BALTIMORE GAS AND ELECTRIC COMPANY

Subject: Calvert Cliffs Nuclear Power Plant
Units Nos. 1 & 2; Dockets Nos. 50-317 & 50-318
Request for Amendment to Operating Licenses

Baltimore Gas and Electric Company hereby requests an amendment to Operating Licenses DPR-53 and DPR-69 for Calvert Cliffs Units 1 and 2, respectively, with the submittal of the following proposed changes to the Technical Specifications. All changes apply to both Units unless otherwise indicated.

FIGURE 6.2.1

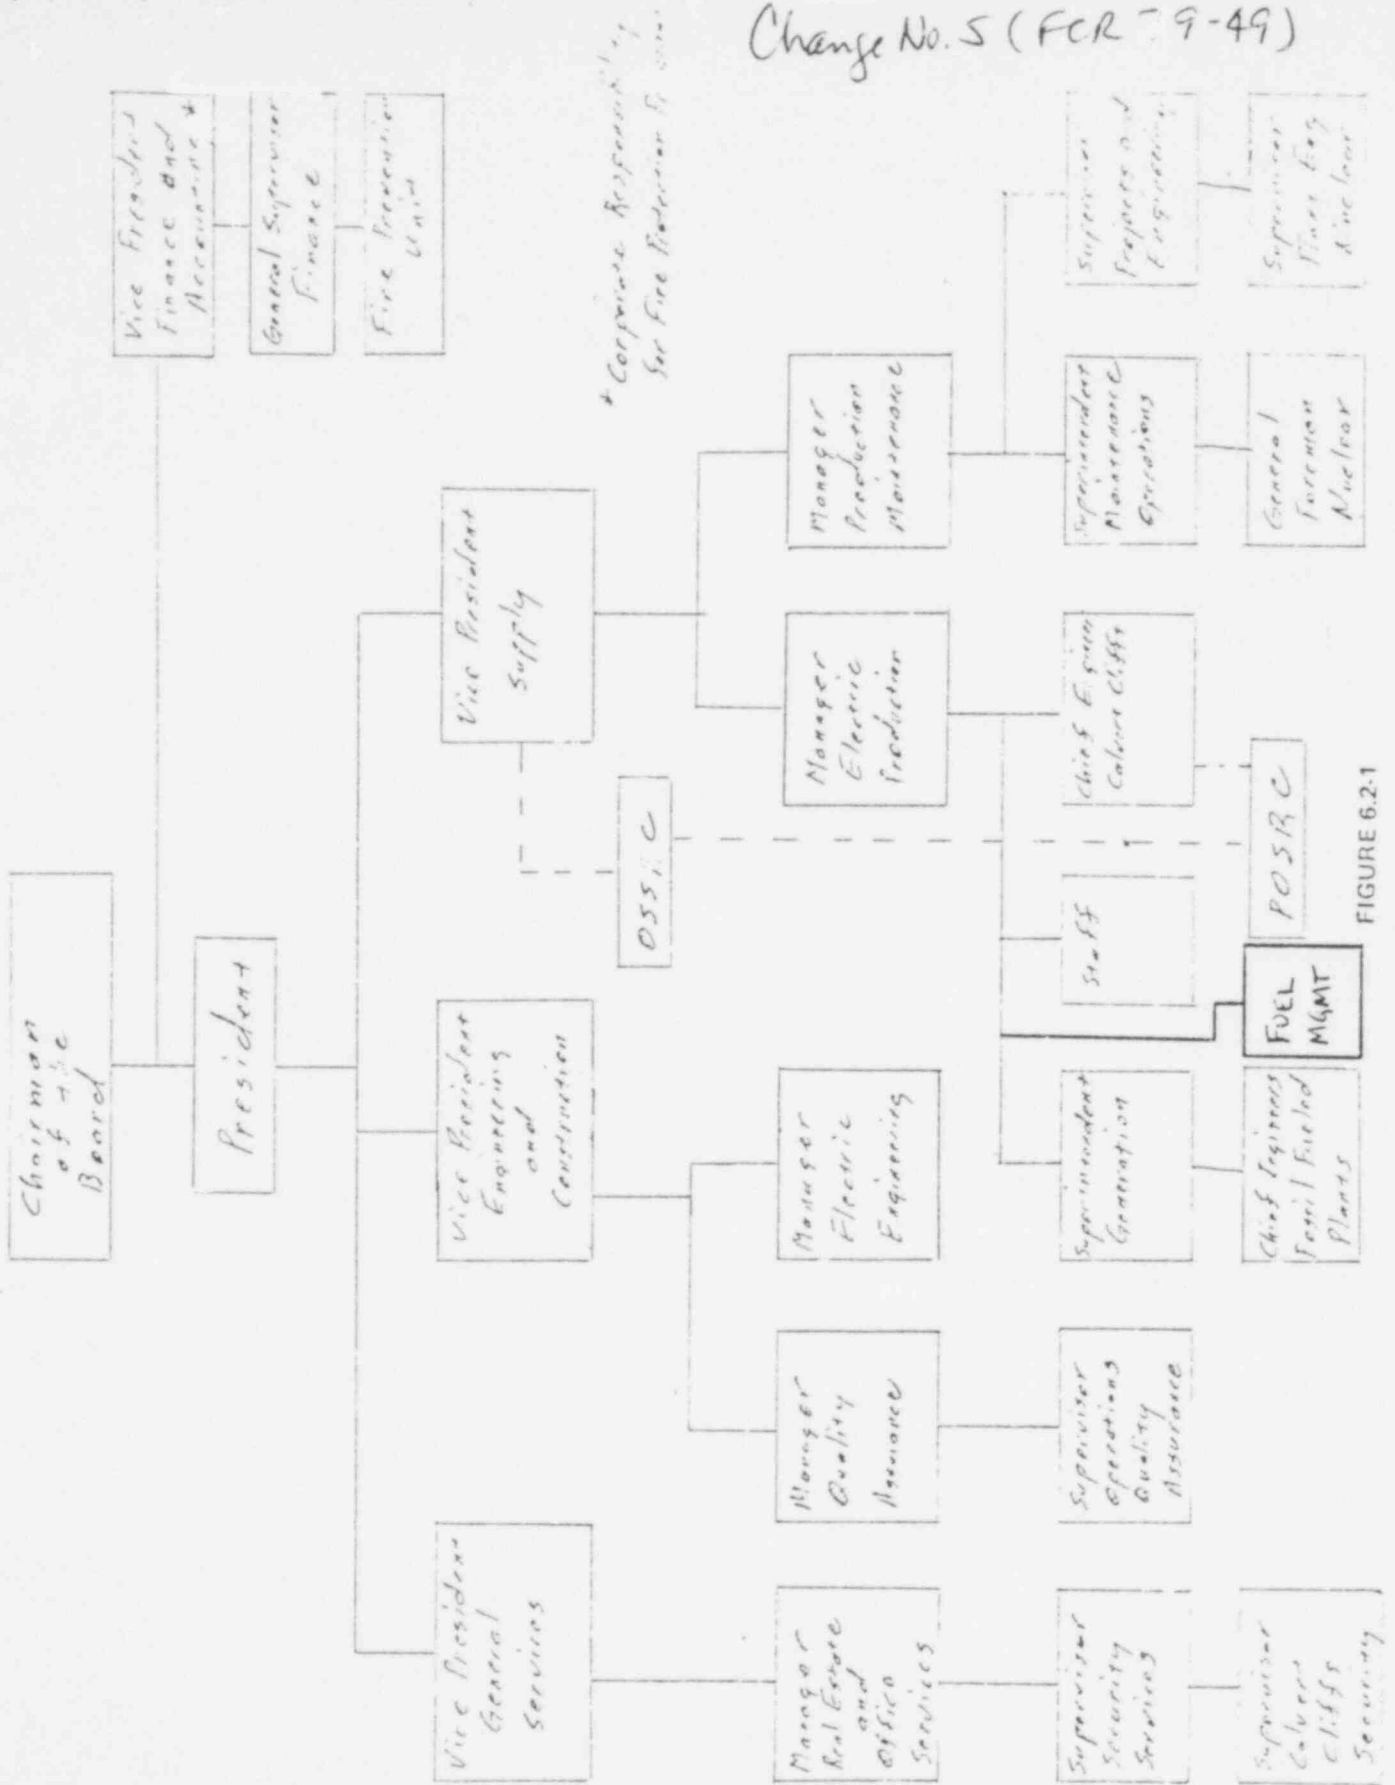
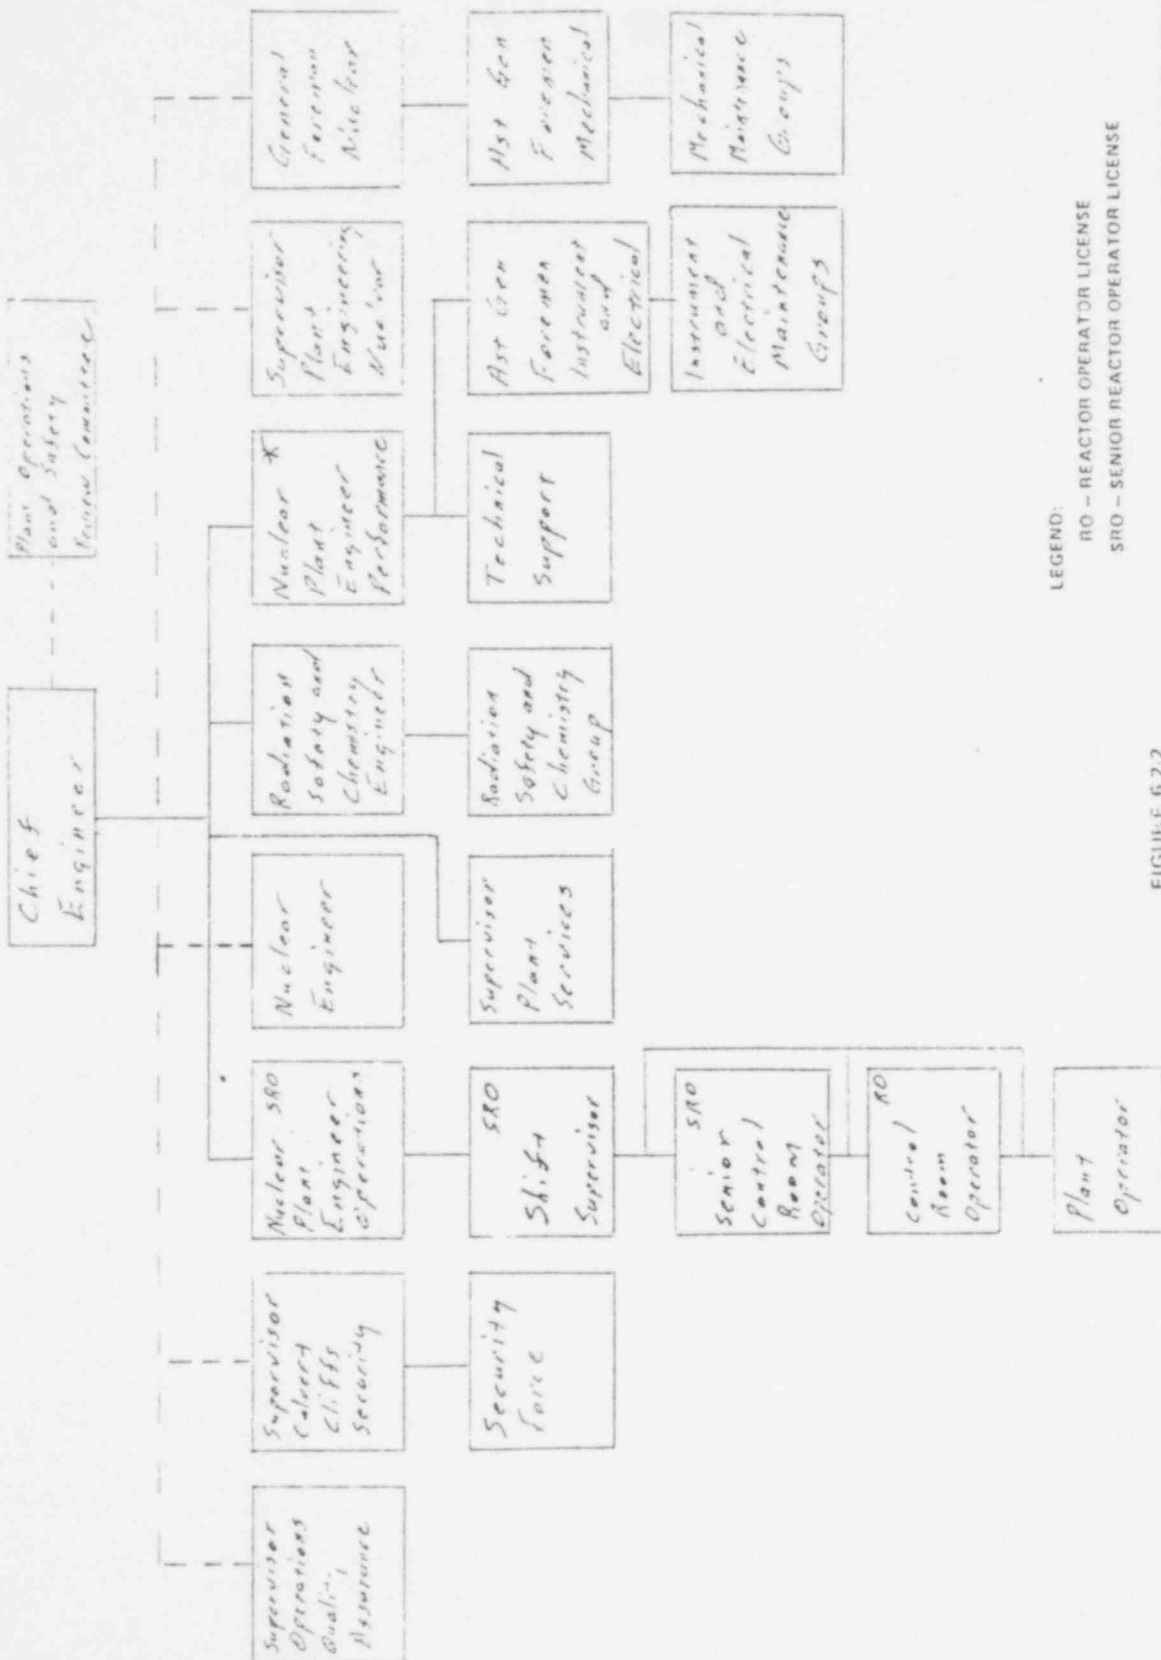
(FCR 79-49): Change paragraphs 6.2 and 6.5 as shown on the attached pages to reflect the institution of the new Production Maintenance Department (Effective July 1, 1979). This change involves both organization chart changes and Off-Site Safety and Review Committee (OSSRC) membership changes.

The Production Maintenance Department is a new Department within the Supply Division which has taken over most of the plant maintenance functions for Calvert Cliffs. As a result, there have been necessary changes in the Company and Plant organization charts to reflect the modified administrative channels. In addition, since some of the expertise which was previously contained within the Electric Production Department, and which constituted part of the OSSRC, is now in the Production Maintenance Department, it is necessary to reflect those changes in the appropriate sections of the Technical Specifications of both Units. These changes are considered to be strictly administrative in nature and have no impact on overall plant safety or the health and safety of the public.
